**Re: Administrative Adjustment 99-7: Administrative Adjustment to reduce the number of required parking spaces from 121 to 110 and allow parking within the front yard setback on property zoned "TF-3" Two-Family and generally located south of 21st Street North and west of Carmen Drive.**

## STAFF REPORT

CASE NUMBER: CU-507

21st STREET HOTEL  
WICHITA, KANSAS

ARCHITECTURAL SITE PLAN  
SCALE: 1" = 20'-0"  
FILE# 21CRS171

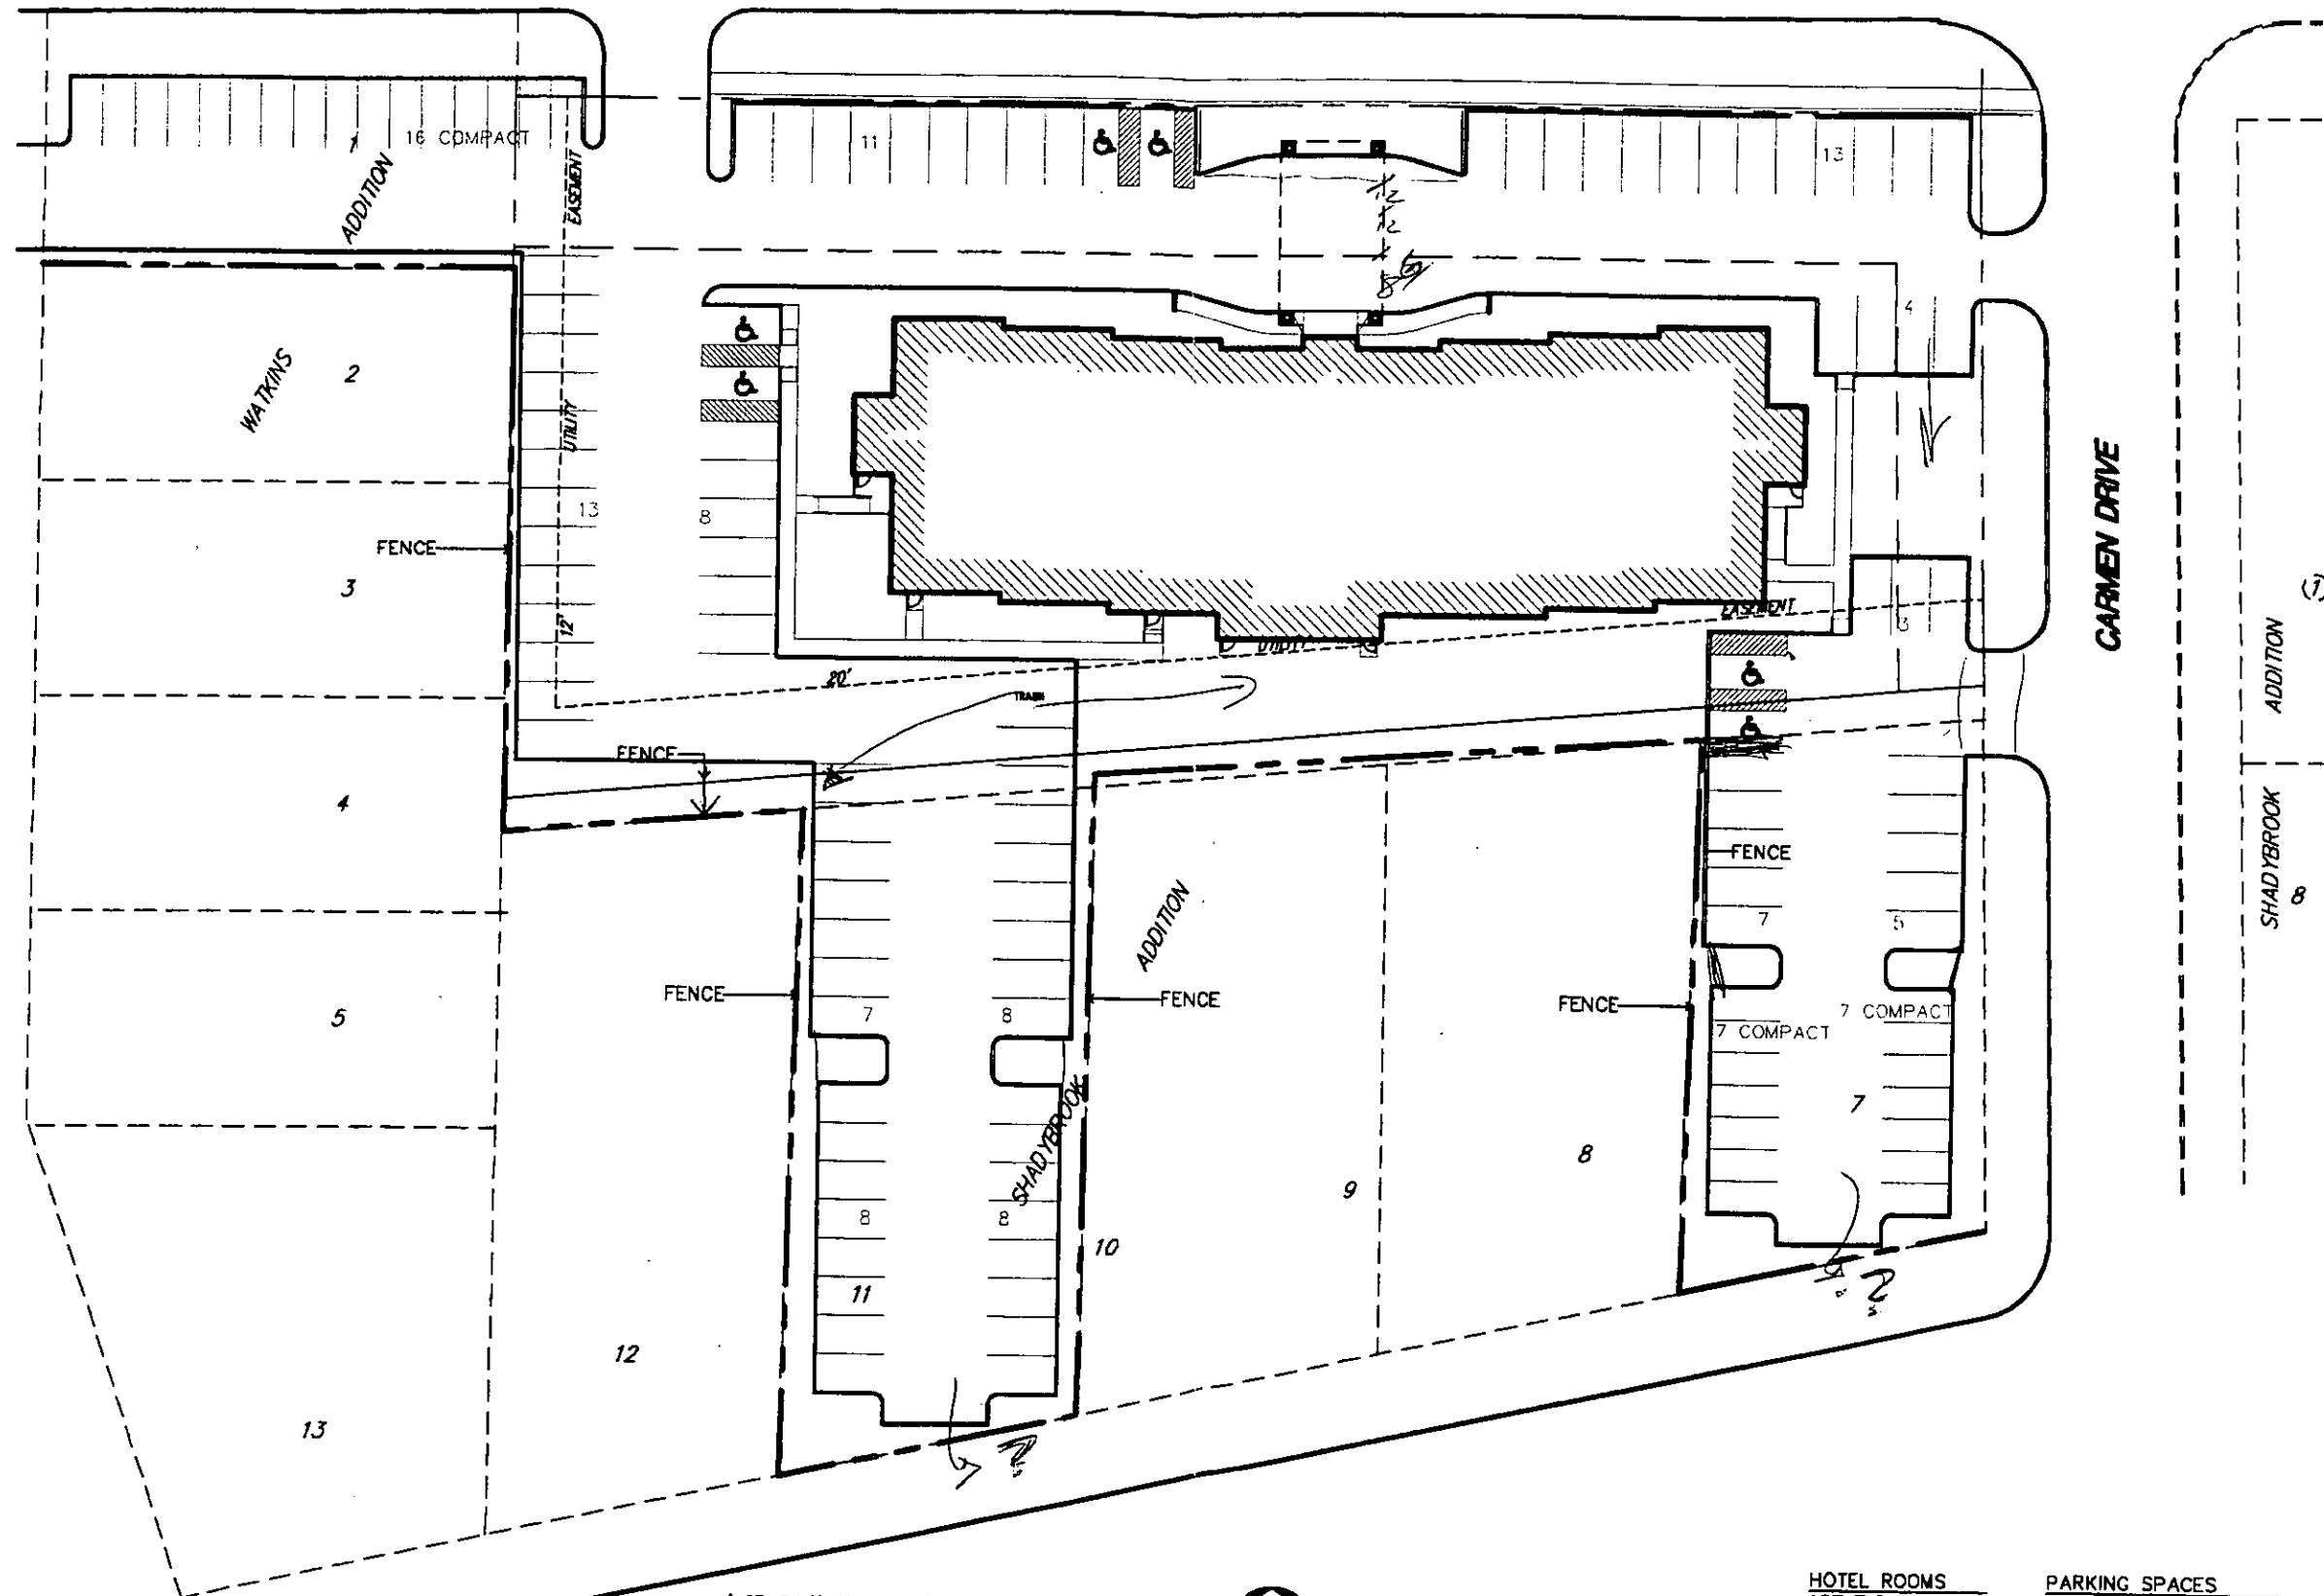
Lighting - Code requirements

Crawford Lighting } spill over lighting will be reduced by fence;  $\frac{1}{2}$  distance from neighboring lot unless shielded to be away from residential use

Consider: Fence - not a wall

Sum: Ht. not to exceed li

no higher than  
max 16' effect in height
